3. 117 Preble Street

5. Thompsons Point

5.I. The Forefront At Thompson's Point Request For Tabling

L7.0 -- LIGHTING PHOTOMETRICS PLAN

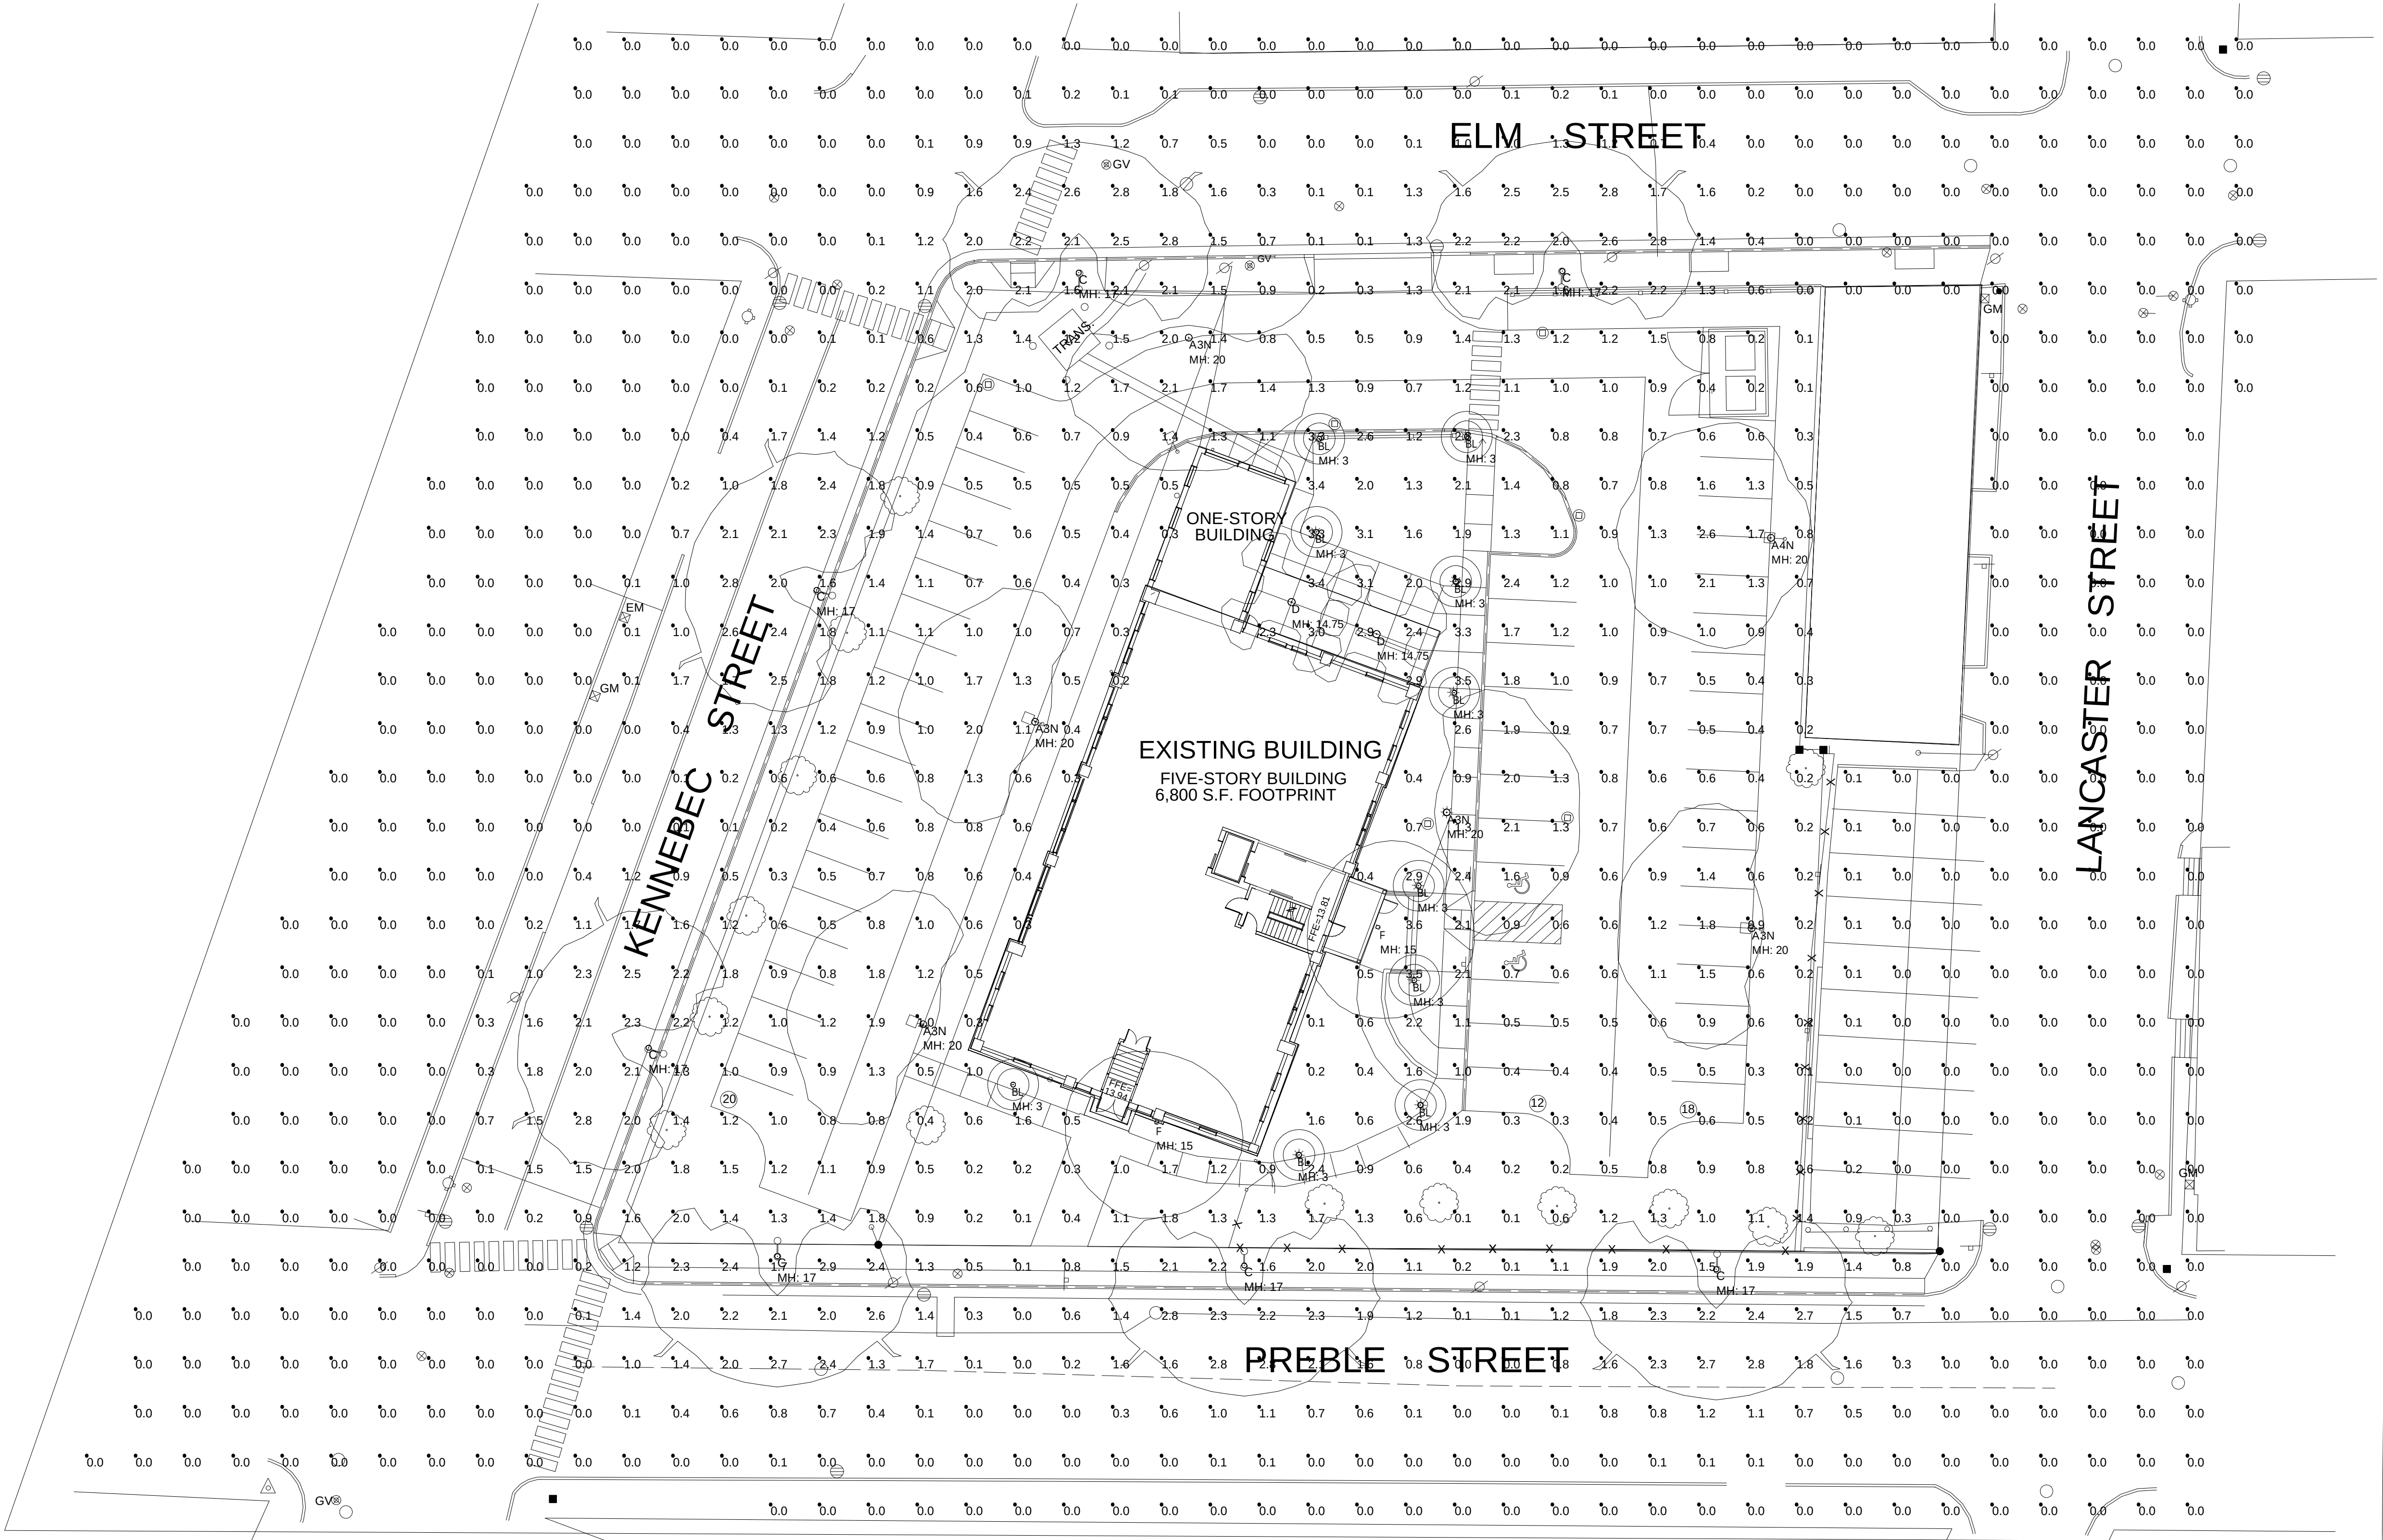
5. Bayside Light Fixture: The proposed Bayside light will be an LED fixture. See Sheet L7.0 – Photometrics Plan, submitted on October 26, 2015. The applicant intends to locate the light bases in the City ROW; easements will not be required.

Plan 59

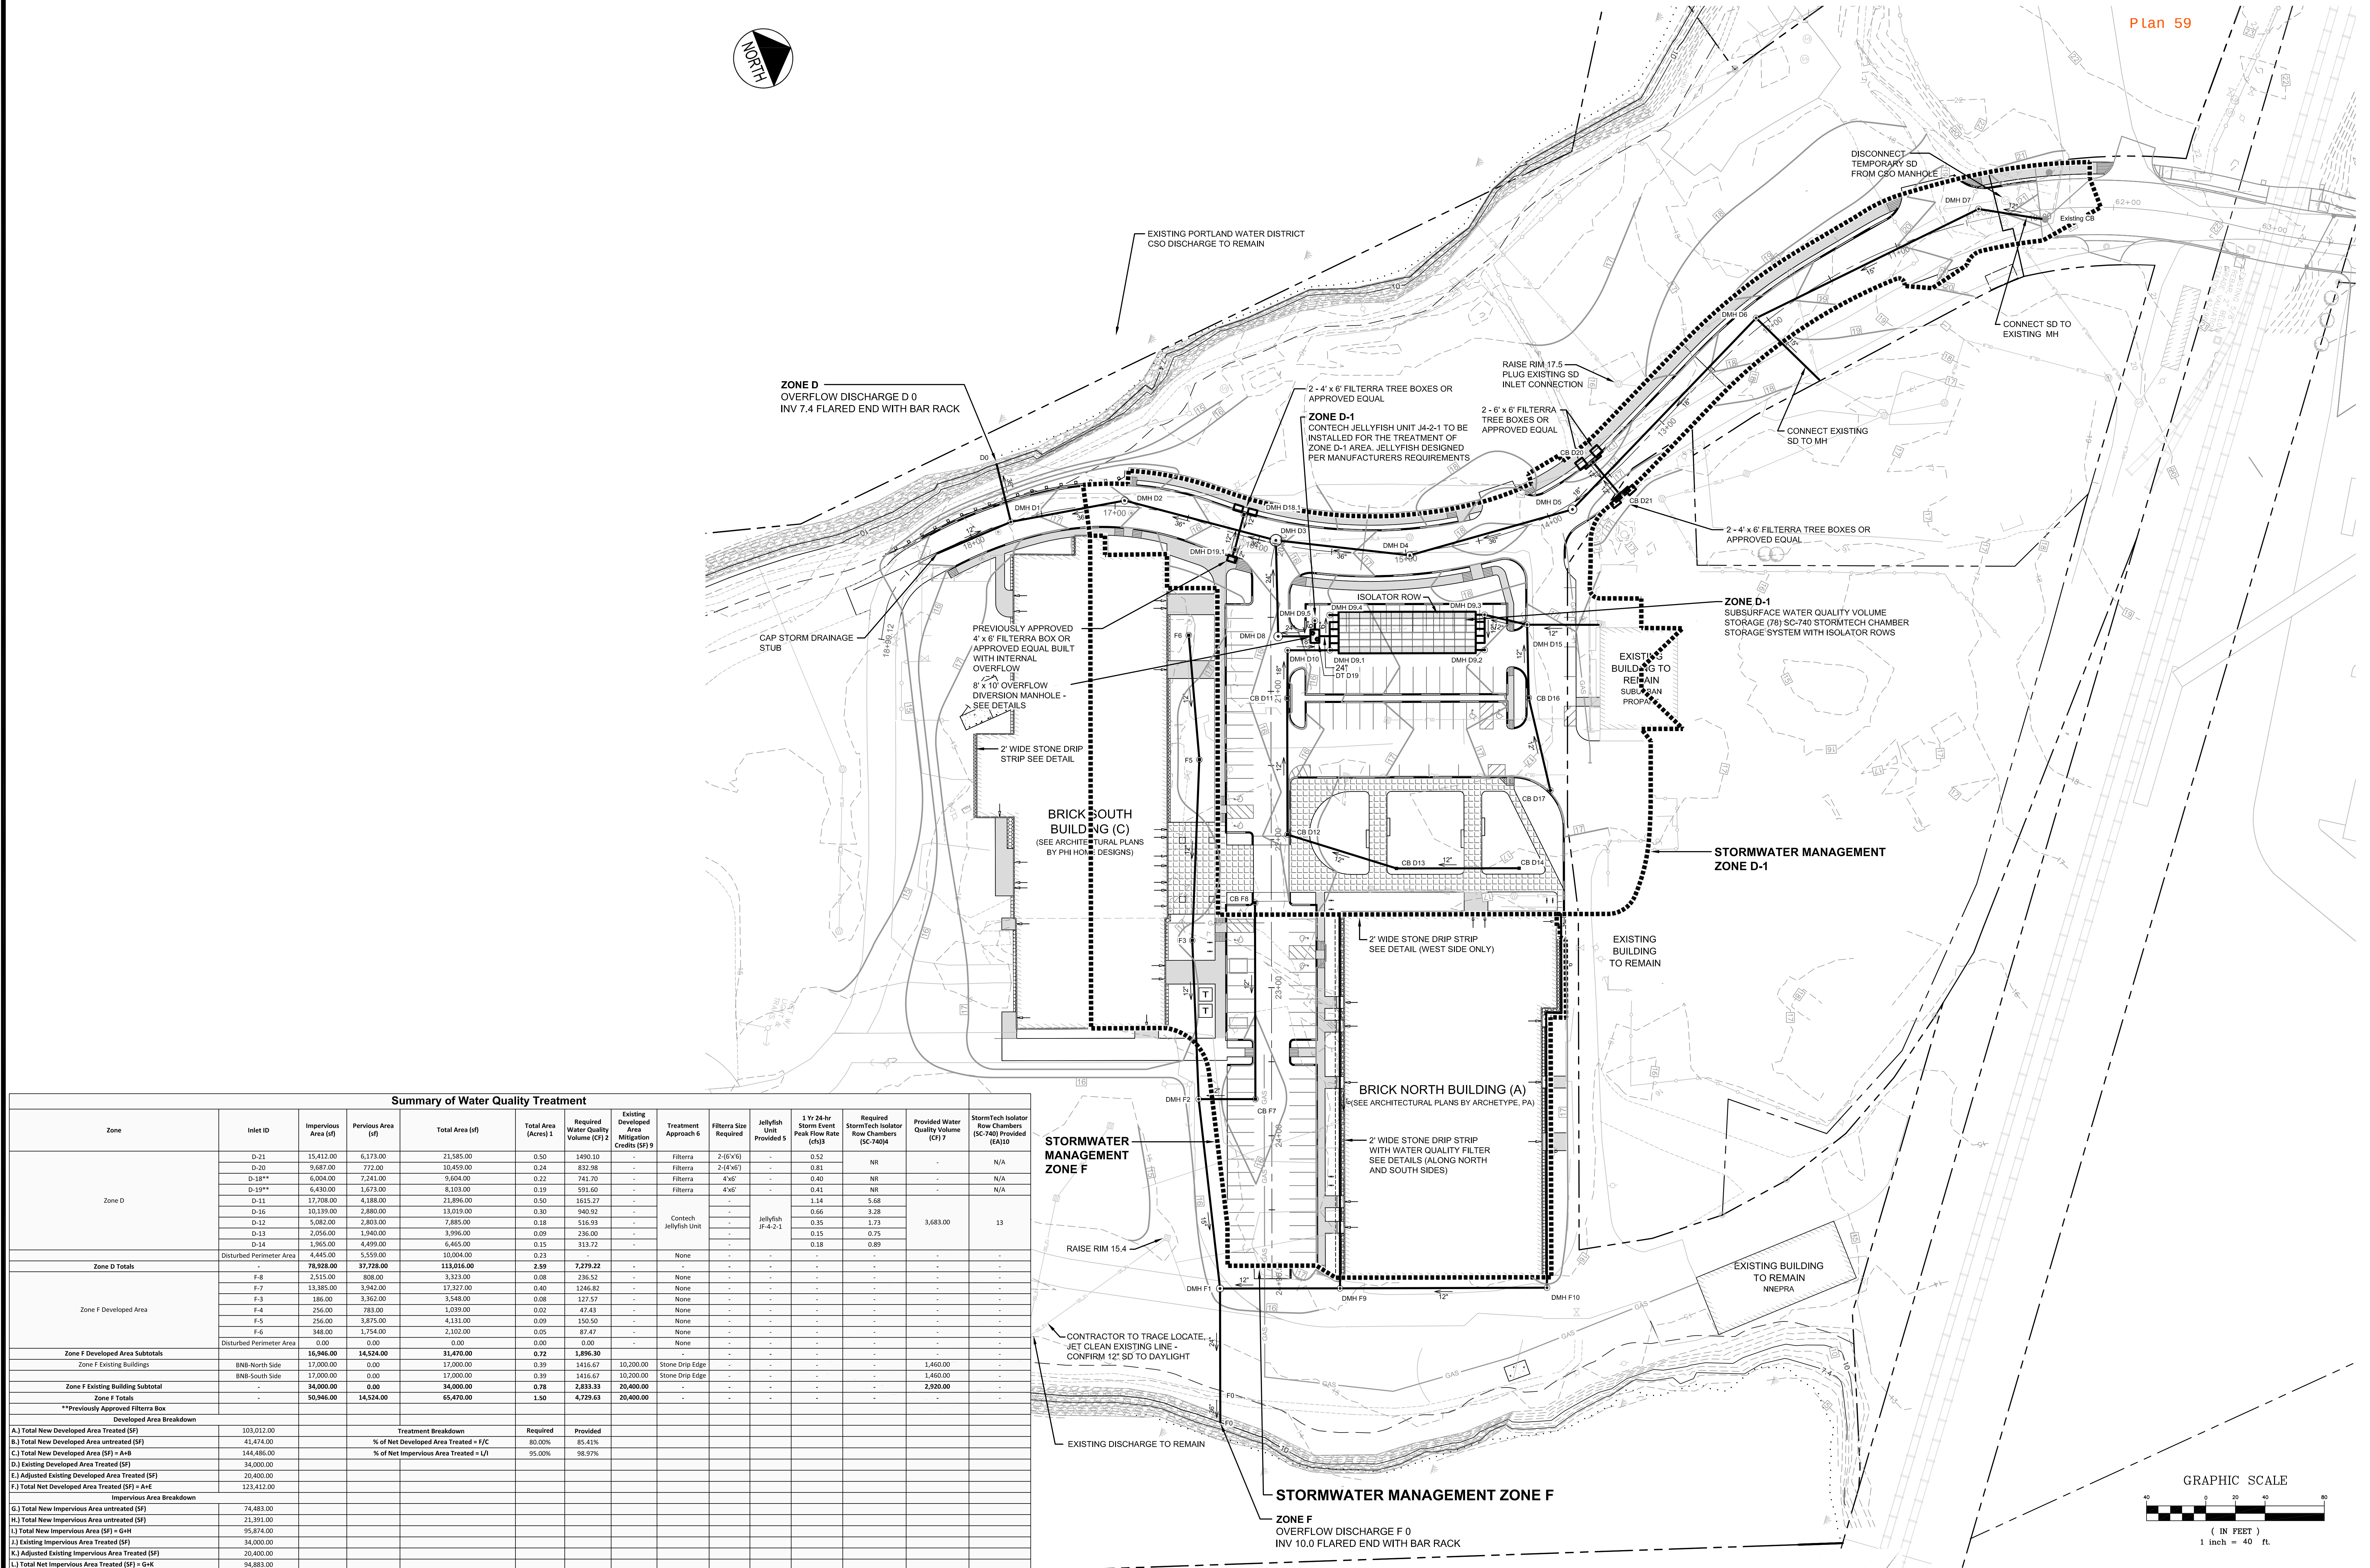
1. Future phases of work in the vicinity of the outfall associated with "Stormwater Management Zone F" (as depicted on sheet C-4.1 of the Subdivision Application) shall incorporate water quality treatment measures that provide adequate treatment capacity for runoff from the untreated parking lot south of the Brick North Building in accordance with the General Standards. If no future work occurs on the site, the Applicant will not be held to completing this measure;
2. The applicant shall provide a full construction management plan for review and approval by the Public Works Department; and
3. Final exterior lighting fixtures shall be reviewed and approved by the Planning Authority in accordance with Sec. 14-526.d.6 *Site plan standards, Exterior Lighting*, prior to Certificate of Occupancy.
